STAFF RECOMMENDATION
602 Taylor Street
November 19, 2018

Application: New Construction - Infill
District: Germantown Historic Preservation Zoning Overlay
Council District: 19
Map and Parcel Number: 08112041500
Applicant: Dallas G. Caudle, Smith Gee Studio
Project Lead: Jenny Warren, jenny.warren@nashville.gov

Description of Project: Application for the new construction of a two-story commercial building. **Recommendation Summary:** Staff recommends approval of the proposed new construction with the following conditions: 1. The exposed concrete foundation wall along the western end of the Taylor Street elevation shall be articulated; 2. MHZC staff approve following materials prior to purchase and installation: a brick sample, the color of the corrugated metal, the exterior stair and railing material, the plaza pavers and all windows and doors finding that the project meets Section III of the *Germantown Historic Preservation Zoning District: Handbook and Design Guidelines*.	**Attachments** **A:** Photographs **B:** Site Plan **C:** Elevations

Figure 1: Site of proposed new construction

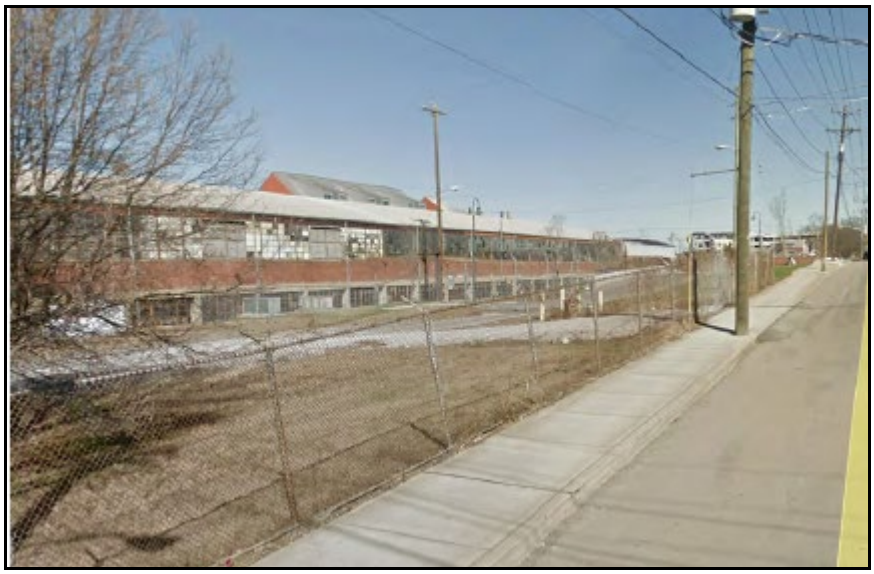
Background: 602 Taylor Street is a proposed new building which will be located within the Werthan Complex Development Zone. The site is currently a parking lot and vacant lot along the north side of Taylor Street, just west of where 6th Street terminates at Taylor. The site experiences a significant drop in grade, falling away from Taylor Street, and dropping off to the west. The building is proposed to be sited along Taylor, in front of the eastern portion of the existing Werthan warehouse building.
